MAYOR AND COUNCIL OF THE TOWN OF WINDERMERE

January 24, 2023

Re: Third Town Council Workshop Windermere Downtown PUD Final Engineering Plan

WINDERMERE
DOWNTOWN
PROPERTY

6TH AVENUE LOOKING EAST

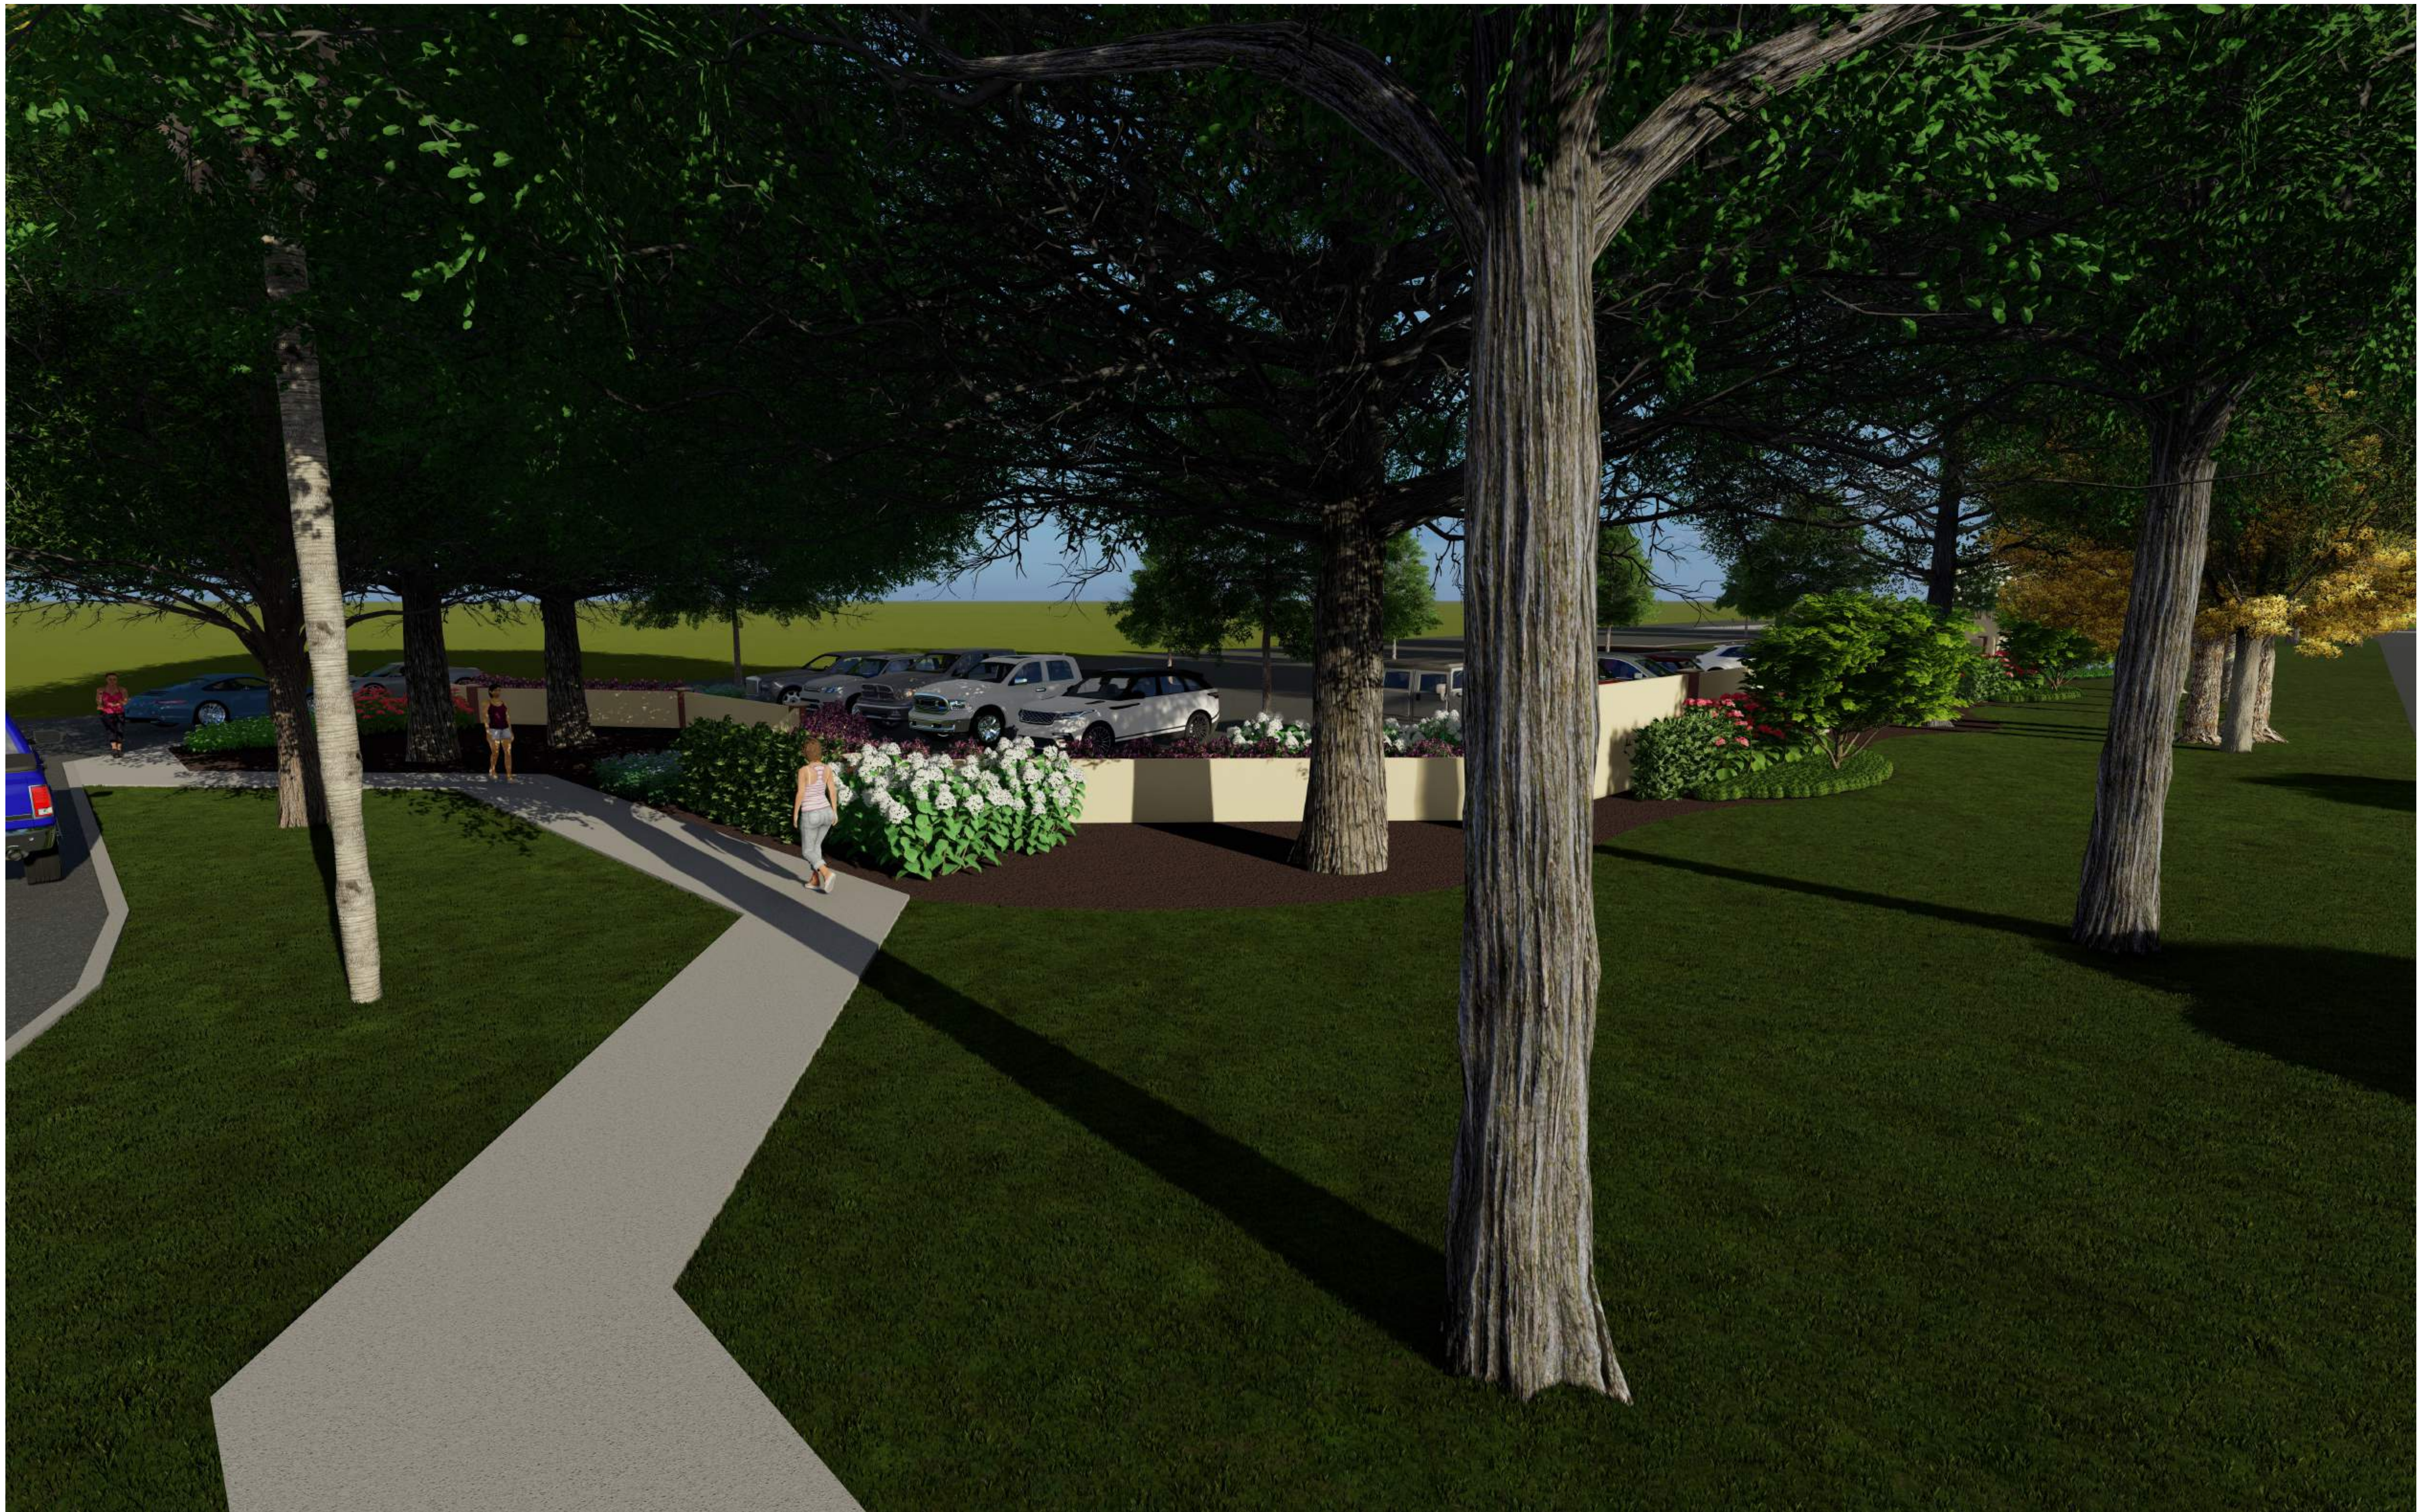
4. The renderings submitted for the buffer wall and landscape give me great concern. The renderings have no connection or relationship to the existing conditions of the area. The renderings appear that there is a parking lot in a middle of a grass field somewhere in the mid-west with no other buildings or other development. Even with my extensive time working with the Town, it is extremely difficult to determine the relationship of the renderings to reality. Another item that gives me concern is that the roads and parking appear to be paved with asphalt. I know that is not the intent; however, that is what is shown on the renderings and can be easily misunderstood. The renderings provided for the buildings are more appropriate as they provide the context of the existing conditions. The renderings for the buffer wall and landscaping should provide that same context to appropriately and correctly relate to the existing conditions. This is not a requirement of the Town's Land Development Code or PUD; however, presenting renderings that are not correct and misrepresent the context are not supportive of a positive response to the plans. Here is an example. According to its title, this submitted rendering is the corner of E 6th Avenue and Oakdale Street:

This rendering appears to be somewhere other than in the Town of Windermere and certainly not in the middle of the Town. Renderings should give context to communicate the expected outcome of the improvements related to the area where it is placed. In my opinion, the submitted buffer wall and landscape renderings only add confusion and misunderstanding about the intent of the project and

buffer wall and landscaping.

- The concerns on the provided renderings, we are willing to have these pulled from the package if it is causing any confusion. These renderings were completed and provided for illustrative purposes to show how the wall would interact with the site. These were not provided to depict a detailed view of each viewpoint of the site.
- The wall heights provided are based on input from the 2 previous workshops and the original PD requirements. If the request is to keep the wall per what's already detailed in the PD we will keep it as a 6-ft wall in all areas.
- The sign bands shown in the elevations are for location indication only. For final design, we will be adhering to the Town's signage criteria.

IN-LINE RETAIL & ACE HARDWARE BUILDINGS
MAIN ST. - COLORED NORTH ELEVATION SKETCH
NOVEMBER 17, 2022

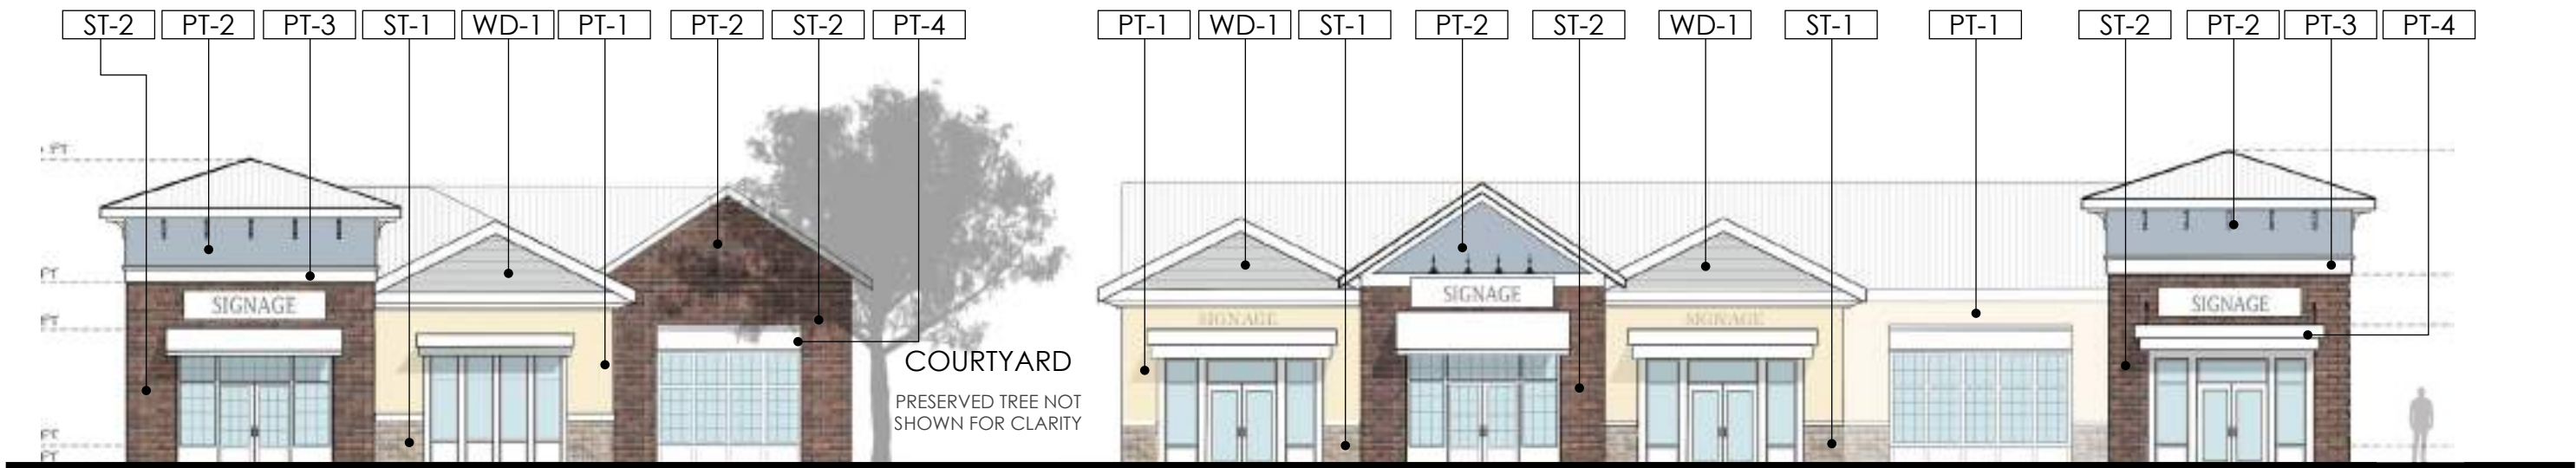
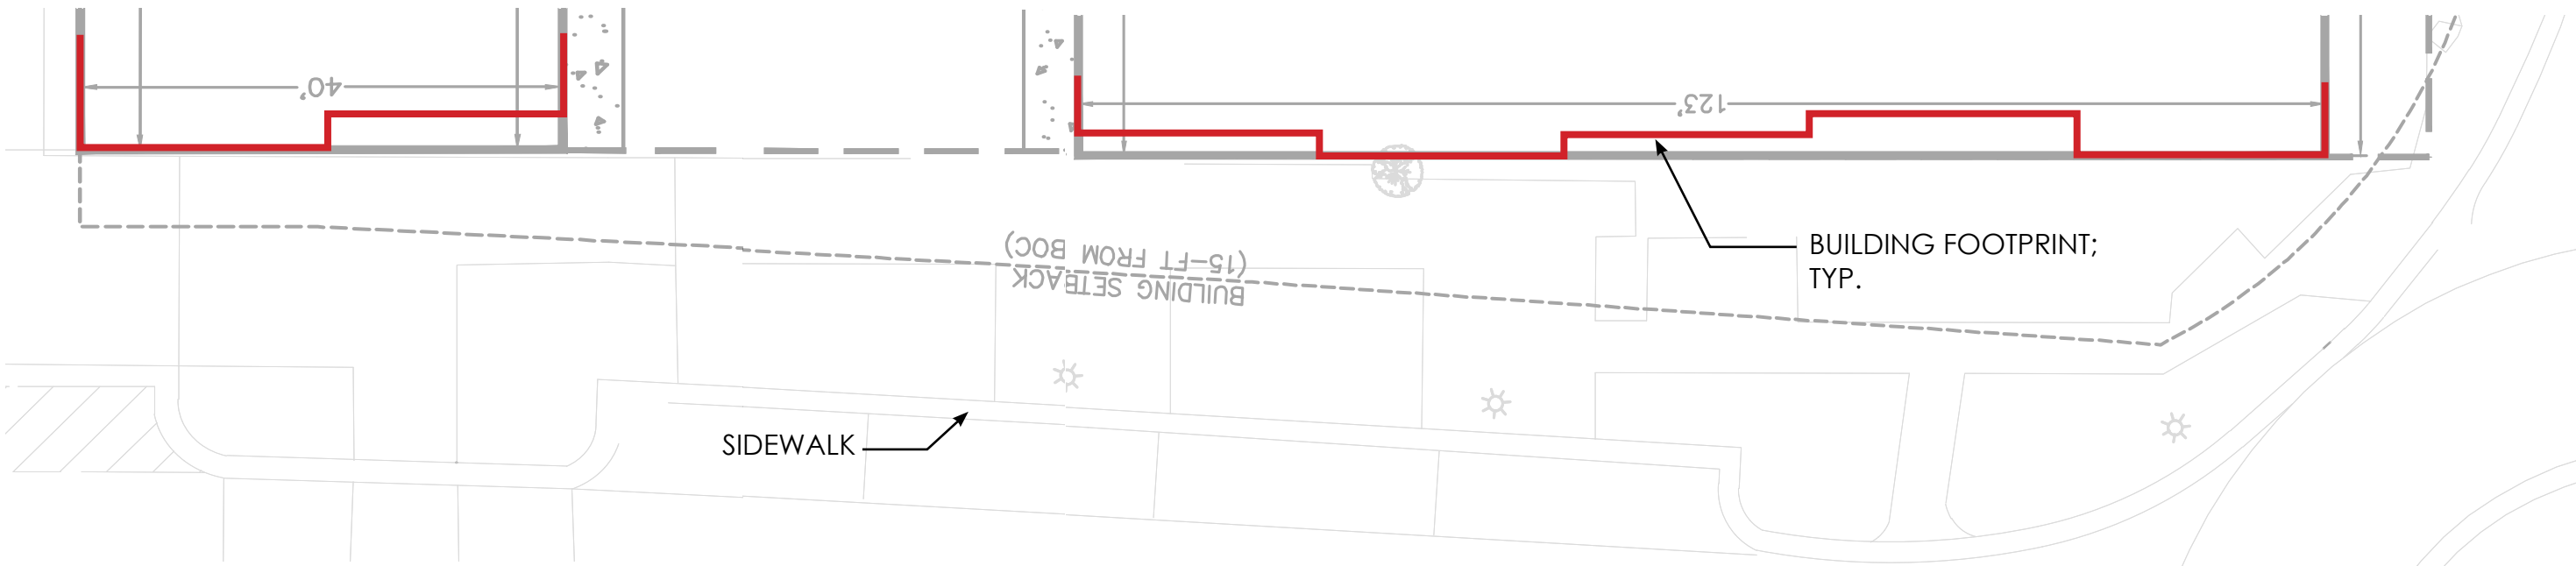
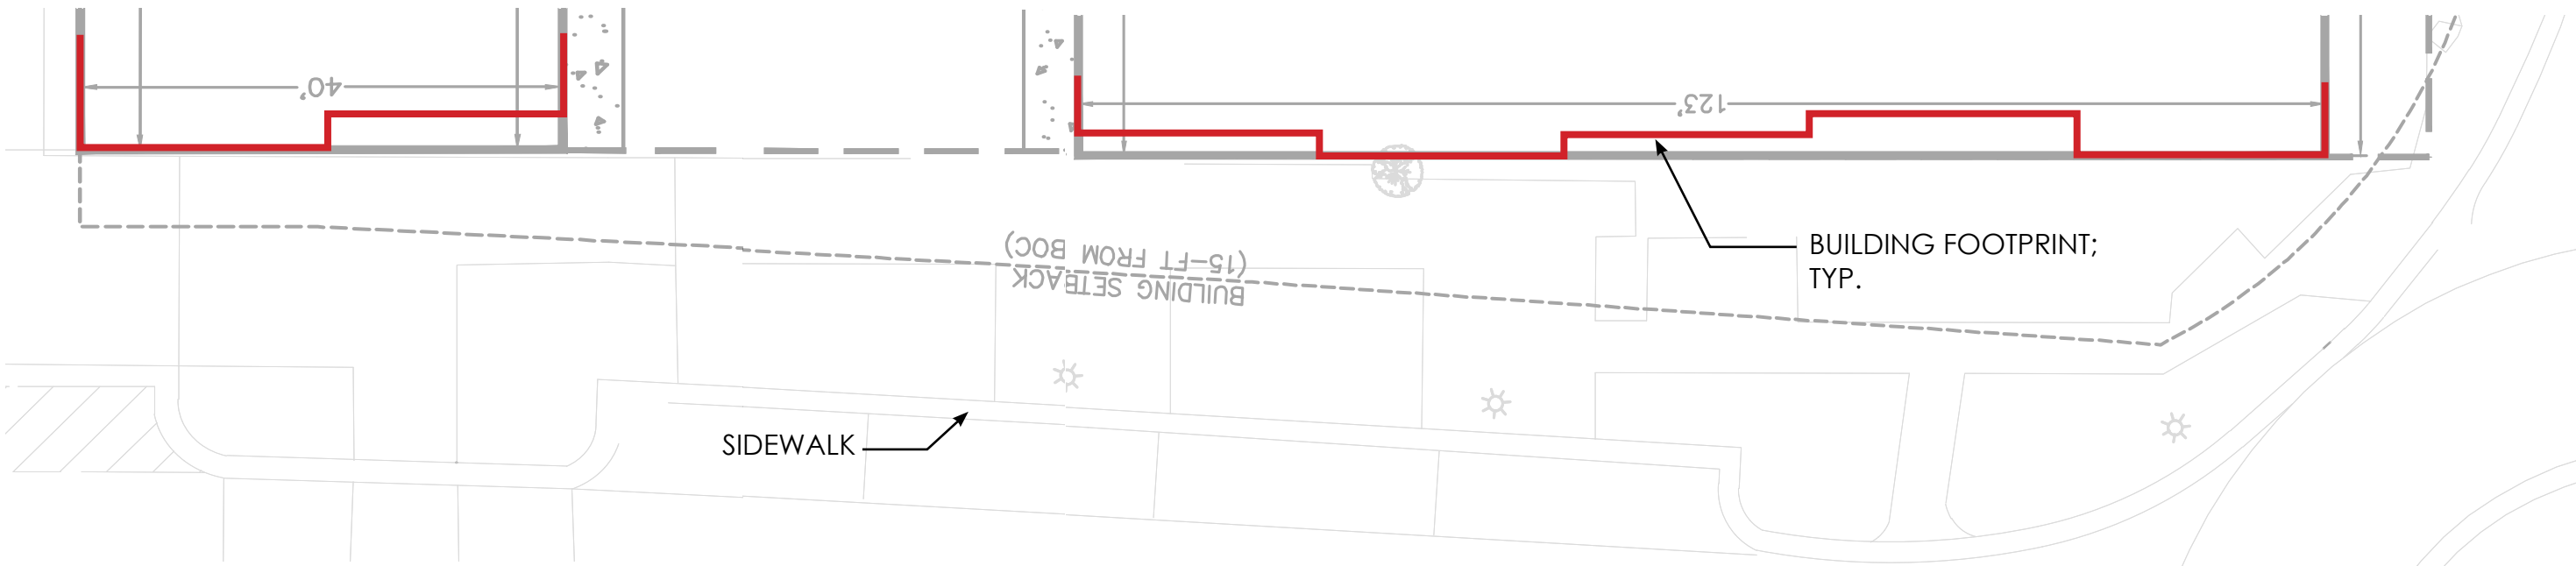
5. The proposed building must be compliant with the architectural standards of Town Center Design District. It will be helpful for the architect to provide with the building renderings a narrative or other documentation that specifically identifies how the building architecture is compliant with the Town Center Design District requirements.
6. The concept signage shown on the submitted building renderings must be shown with their final size/shape/color/location with the final plans for the public hearings. The Town's Land Development Code requires projects with multiple businesses submit a master sign plan for the overall project.

This is a narrative of changes and updates made to the elevation drawings based on the previous Town Council meeting held on September 7, 2022 and the most recent Town Center Design Guidelines document.

1. Colored Elevations have been provided along with proposed materials on the sheets.
2. Materials have been incorporated to meet the city design guidelines

3. Material changes occur at expression lines throughout the elevations per design guidelines.
4. Doors and storefronts have been updated to show kickplates and window heights at 18" A.F.F respectively per design guidelines

5. Canopies have been updated to include valances around the perimeter per design guidelines.
6. Façades are designed to meet the requirement for increments/ multiple of 20 ft. The Proposed building footprints have been adjusted match.

7. South-east corner tower has been lowered in height per the request at town council meeting on Sept 7, 2022.
8. An 'Option B' elevation drawing has been provided for the south-east corner as a tower-less corner.

9. Trees shown in the renderings have been updated to better reflect the actual trees in the surrounding area.
